**Re: DEP File #301-1376
Plan Revision
Jonatas Storck
58 Massasoit Avenue, Sudbury, MA**

In response to comments raised during the October 3, 2022 Conservation Commission meeting we have revised the Design Plan for 58 Massasoit Avenue, Sudbury, MA. The revisions include the following:

PROPOSED HOUSE LOCATION PLAN
"58 MASSASOIT AVENUE"
SUDBURY, MASSACHUSETTS

EXISTING CONDITIONS

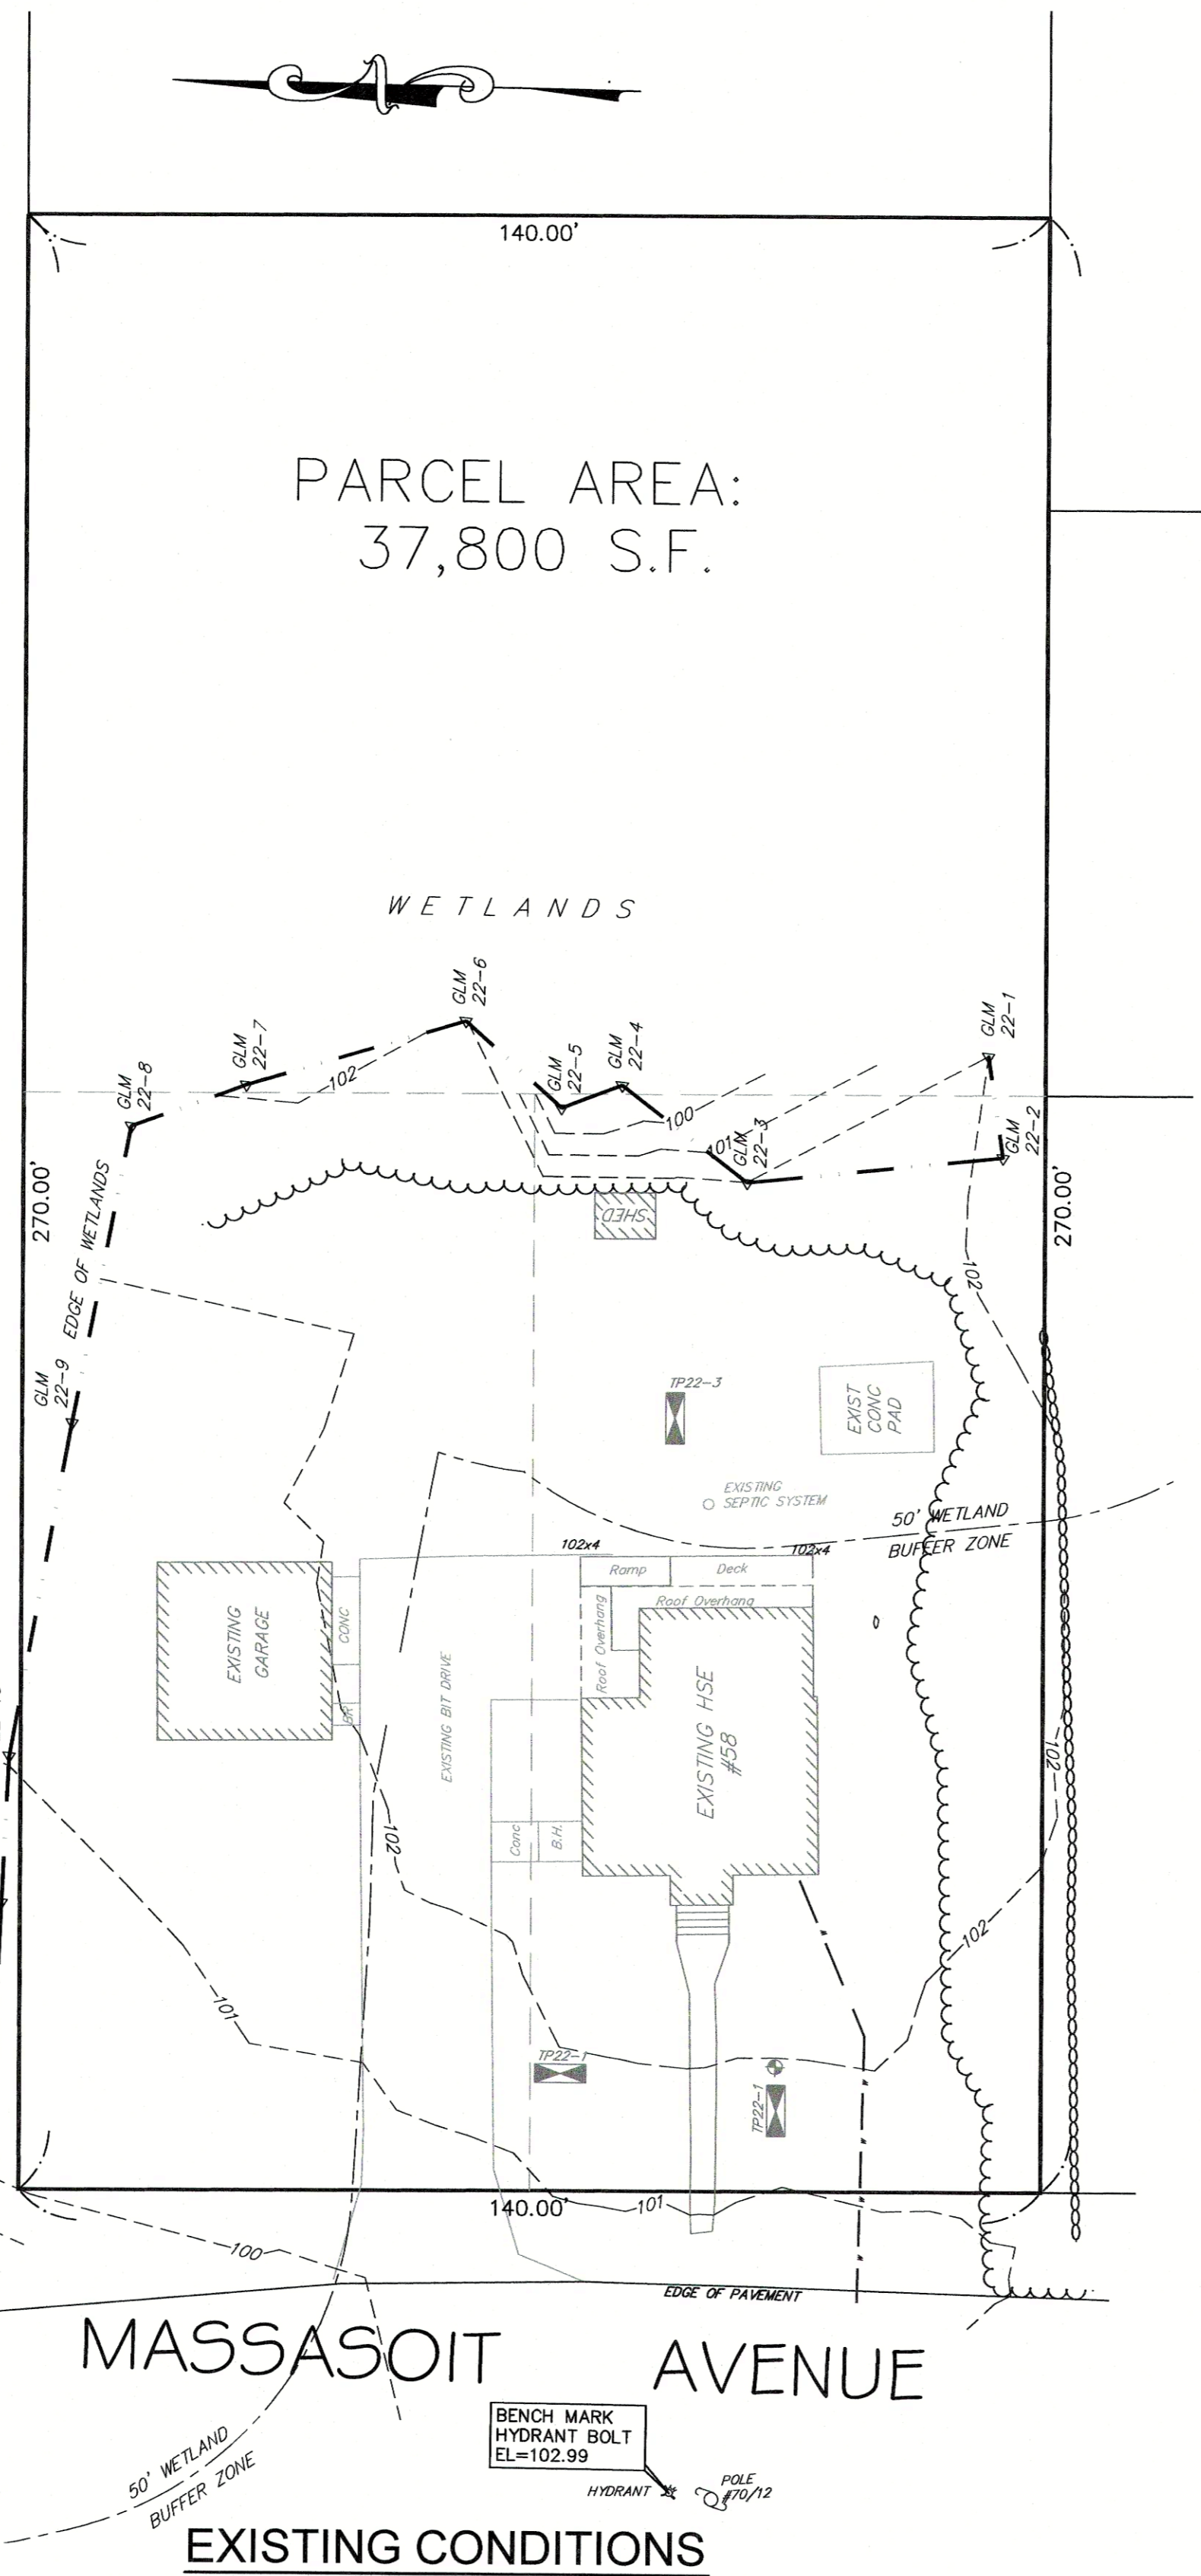
ACTIVITY	100' BUFFER
EXISTING CONDITIONS	
HOUSE & ROOF OH	1,305 S.F.
DRIVEWAY	2189 S.F.
CONC WALK/BULKHEAD	312 S.F.
GARAGE	581 S.F.
SHED	52 S.F.
CONC. PAD	189 S.F.
TOTAL:	4,628 S.F.
EXISTING DECK & RAMP - 130 S.F. (NOT INCLUDED IN IMPERVIOUS AREA)	
PROPOSED CONDITIONS	
HOUSE & PORCH	2,176 S.F.
DRIVEWAY	1,695 S.F.
WALK	161 S.F.
RETAINING WALL	203 S.F.
BULKHEAD	30 S.F.
DECK & STAIRS	180 S.F.
AC UNITS	18 S.F.
TOTAL:	4,463 S.F.

THE PROJECT RESULTS IN A 165 S.F. DECREASE IN BUFFER ZONE ACTIVITY

PROPOSED CONDITIONS

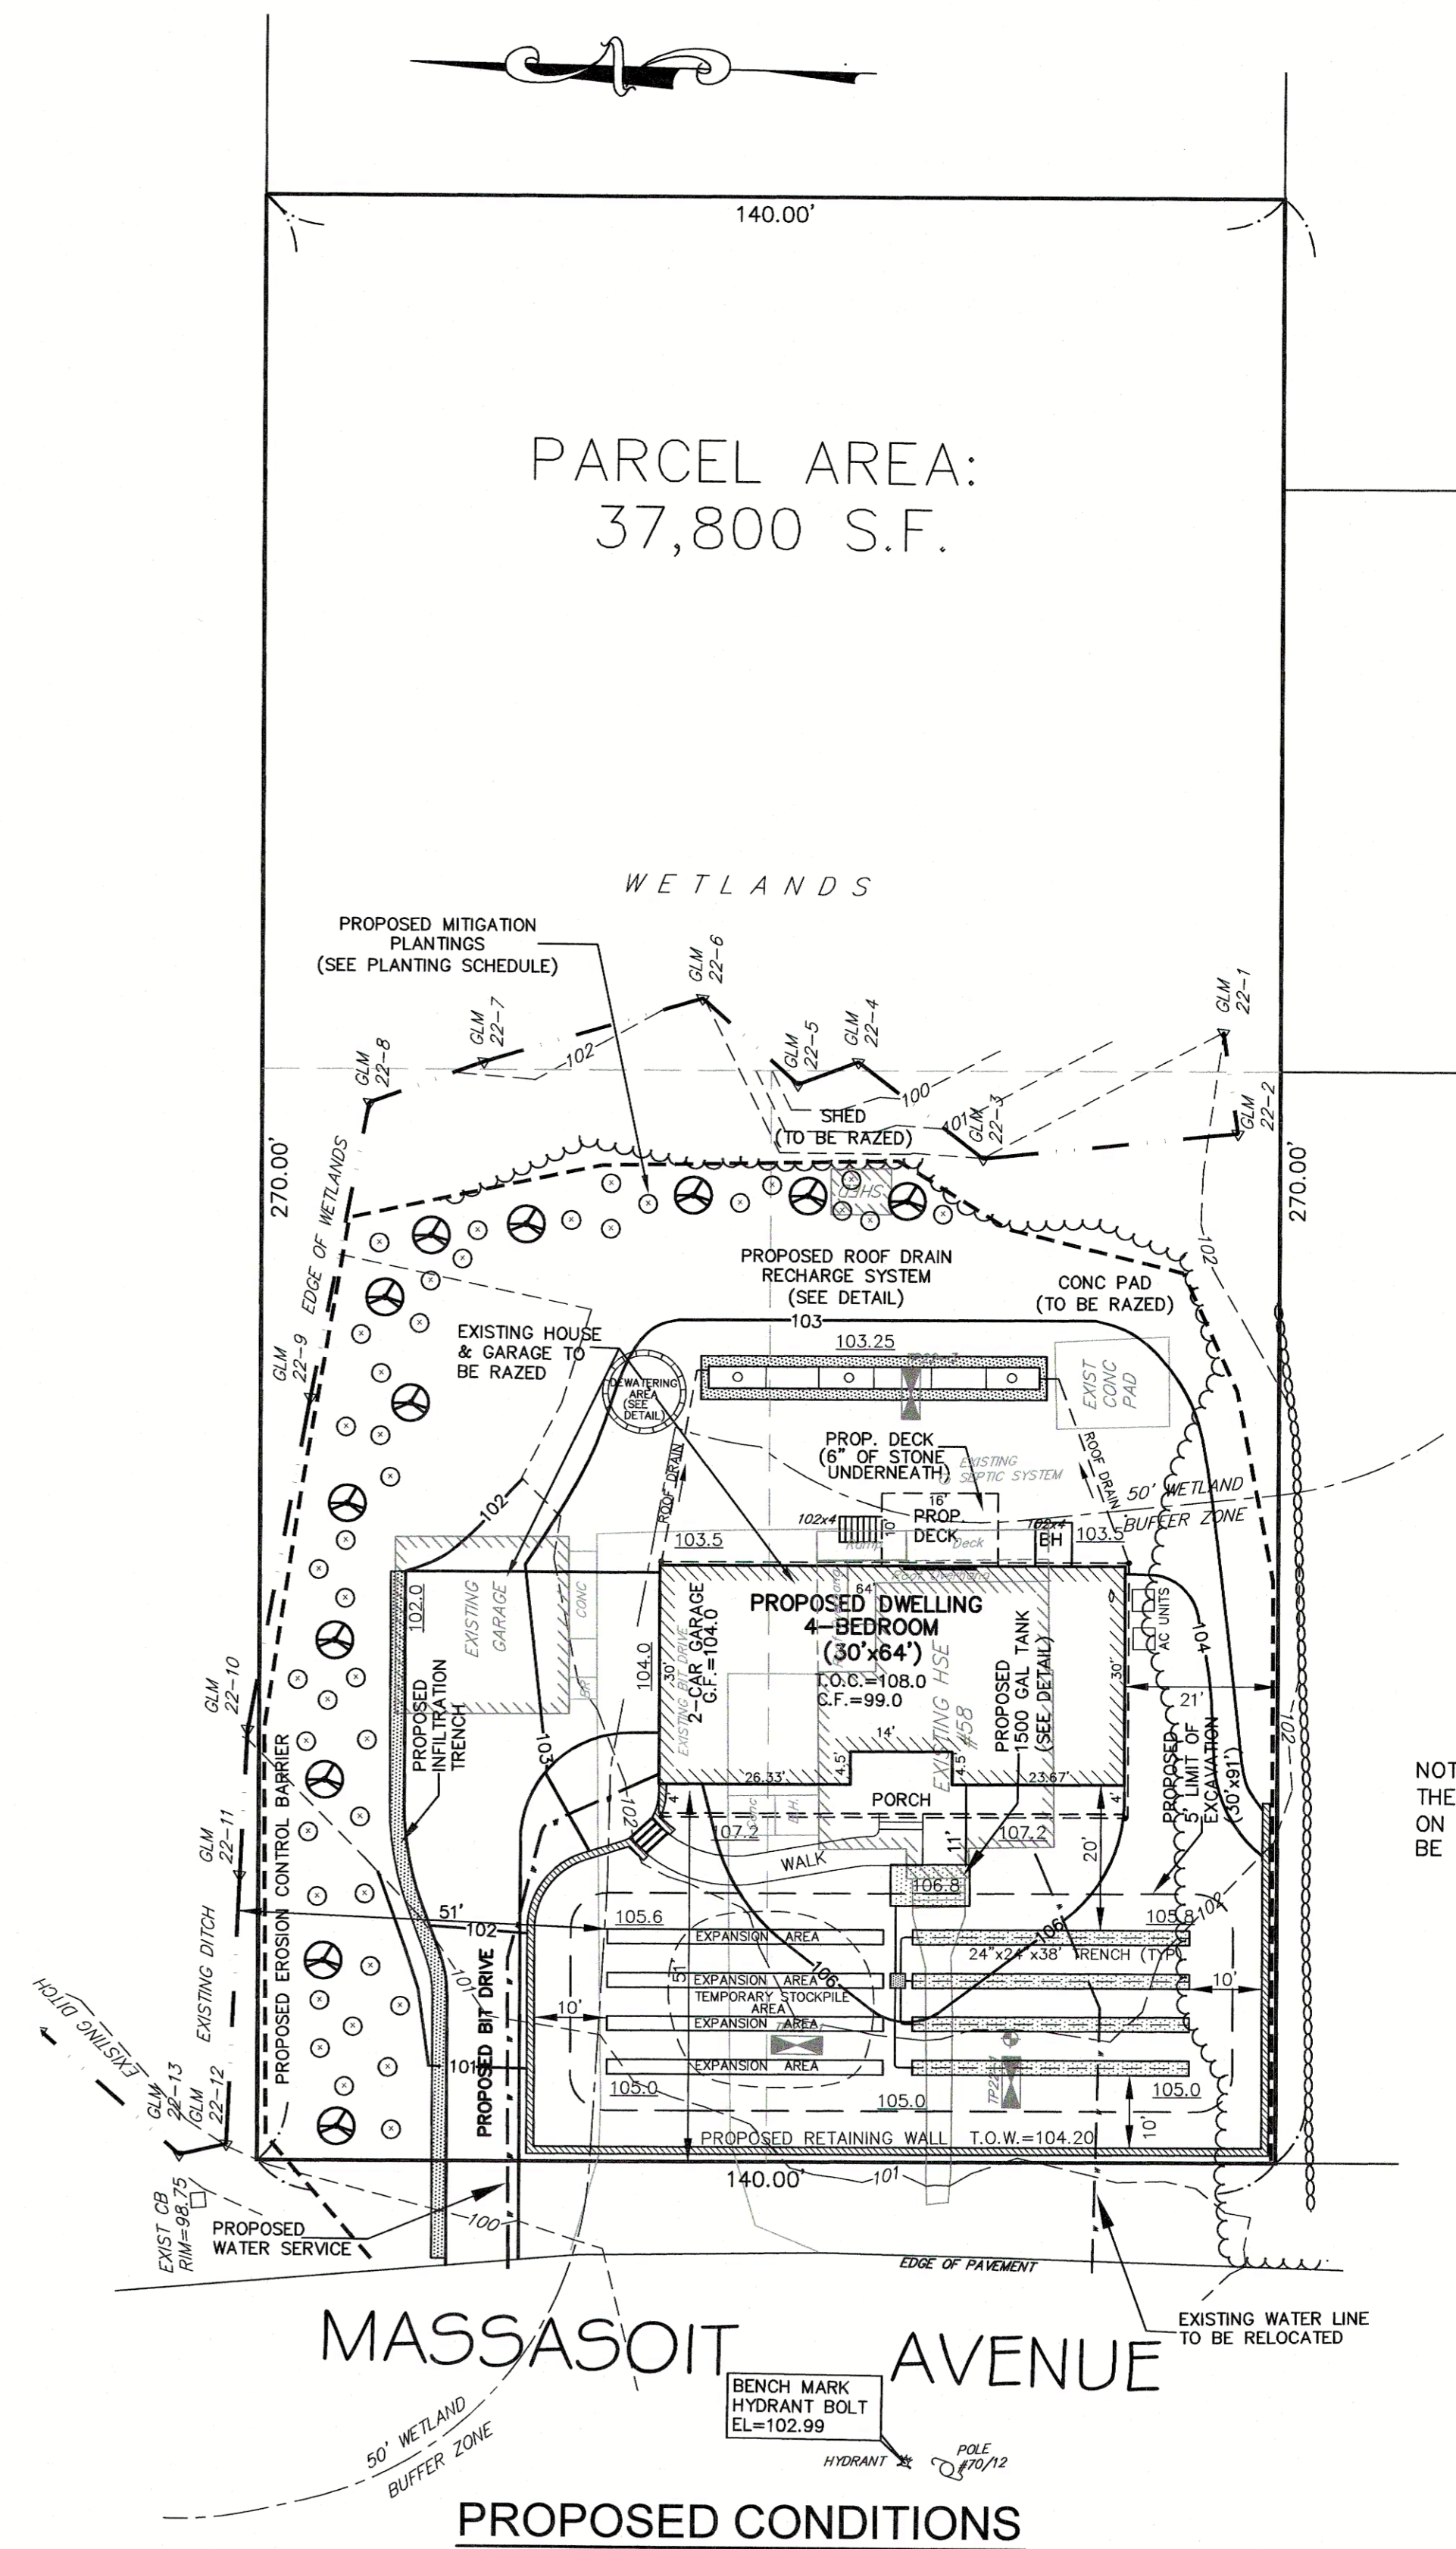
- A dewatering location has been shown on the plan.
- A stockpile area has been shown on the plan.
- The plan has been revised to address the comments of the Board of Health by:
 1. providing a ten-foot separation between the leaching field and the retaining wall;
 2. reconfiguring the retaining wall and the proposed driveway.

This change resulted in an increase in the impervious area retaining wall from 197 S.F. to 203 S.F. and a decrease in the impervious area of the proposed driveway from 1,733 S.F. to 1,695 S.F. The septic reconfiguration decreased the total impervious area by 32 S.F.

- The garage has been labeled “two car garage” for clarity.
- The erosion control barrier has been extended along the southerly property line.

This plan revision now results in a 165 square foot reduction in impervious area.

DE-WATERING DETAIL
 N.T.S.

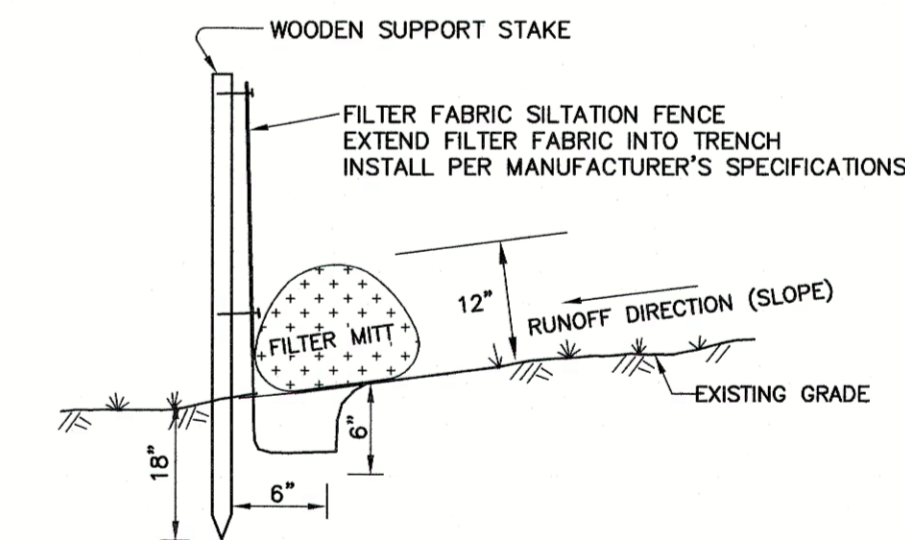
DEWATERING:
 IN THE EVENT DEWATERING IS REQUIRED, GROUNDWATER WILL BE PUMPED FROM THE EXCAVATION AND DISCHARGED INTO A DESIGNATED DEWATERING AREA AS SHOWN ON THE PLAN. THE DESIGN ENGINEER AND THE SUDBURY CONSERVATION AGENT SHALL BE NOTIFIED PRIOR TO DE-WATERING.
